PRIORITY:	Normal
DATE:	March 6, 2000
TITLE:	ALPHA 220C Disassembly and EPROM or Dip Switch Address Changes
ECO REFERENCE:	
PRODUCT(S) AFFECTED:	ALPHA 220C
SUMMARY:	Some signs shipped prior to January 1, 2000 may require a simple modification to keep an unintended disconnection from occurring during disassembly. When EPROM or dip switch address changes are necessary, be sure to follow the same disassembly procedure.

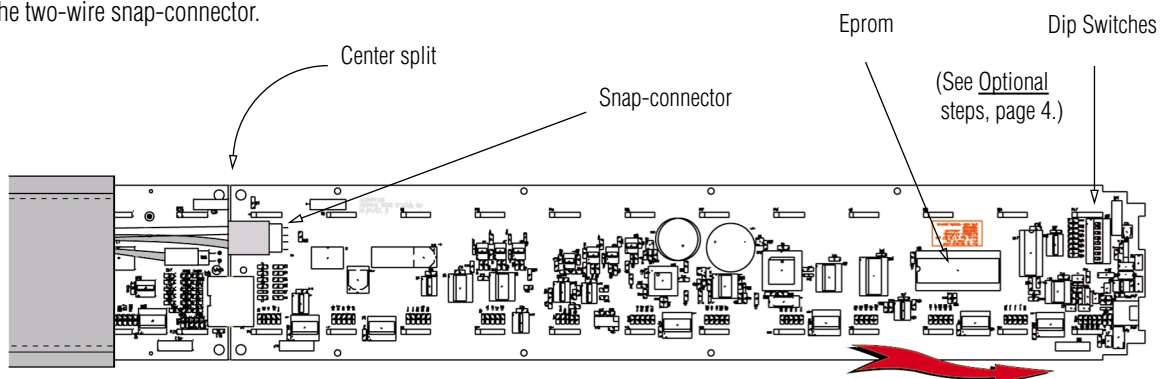
NOTE: You can disconnect the controller board assembly— and disable the sign!— if the 2 screws on the *l e f t* end cap aren't loosened.

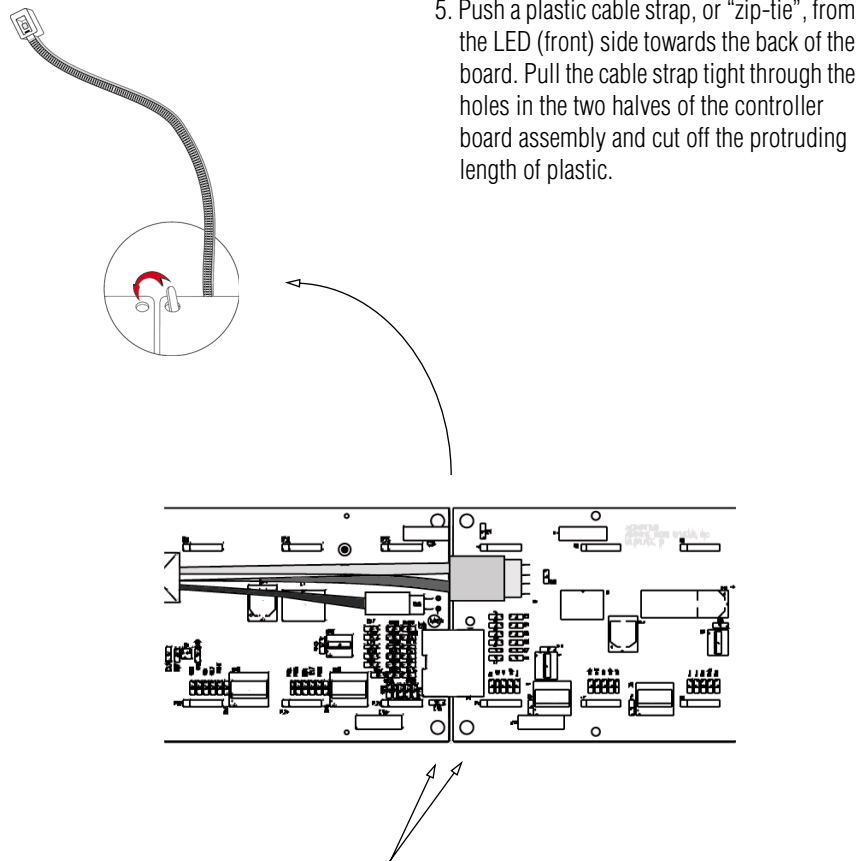
4. Carefully withdraw the controller board from the right side of the sign. Look for the center split between the two halves of the controller board assembly, with the two-wire snap-connector.

5. Push a plastic cable strap, or “zip-tie”, from the LED (front) side towards the back of the board. Pull the cable strap tight through the holes in the two halves of the controller board assembly and cut off the protruding length of plastic.

6. Reinforce both the top and bottom sets of holes.
